PRODUCT / PROCESS CHANGE NOTIFICATION

1.1 Company		STMicroelectronics International N.V
1.2 PCN No.		MDG/22/13205
1.3 Title of PCN		TPM VFQFPN32 – Molding resin upgrade to ULA
1.4 Product Category		VFQFPN32 package for product lines ST33TPHF20, ST33TPHF2E, ST33TPHF2X
1.5 Issue date		2022-01-19

TPM VFQFPN32 – Molding resin upgrade to ULA

VFQFPN32 – Molding resin change for ST33TPHF20, ST33TPHF2E, ST33TPHF2X to Ultra Low Alpha molding resin to improve Soft Error Rate.

How can the change be seen?

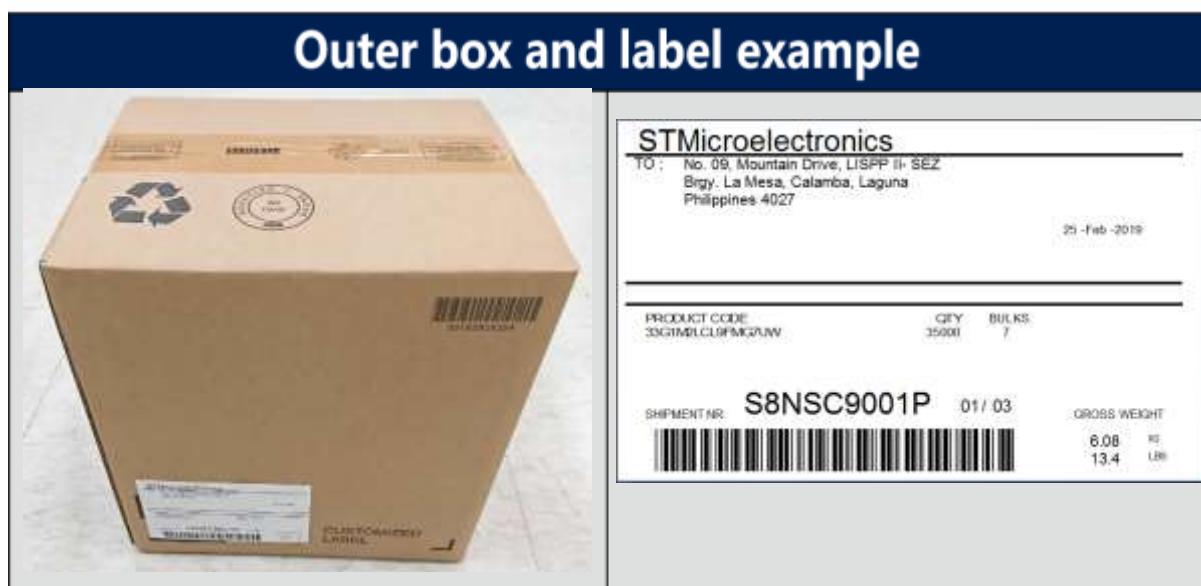
For each Commercial Product impacted by the change, a new Finished Good codification will be created. This Finished Good codification is present on the label.

The Finished Good is provided on the labels of the packing

Example of the outer box with PRODUCT CODE providing the Finished Good codification.
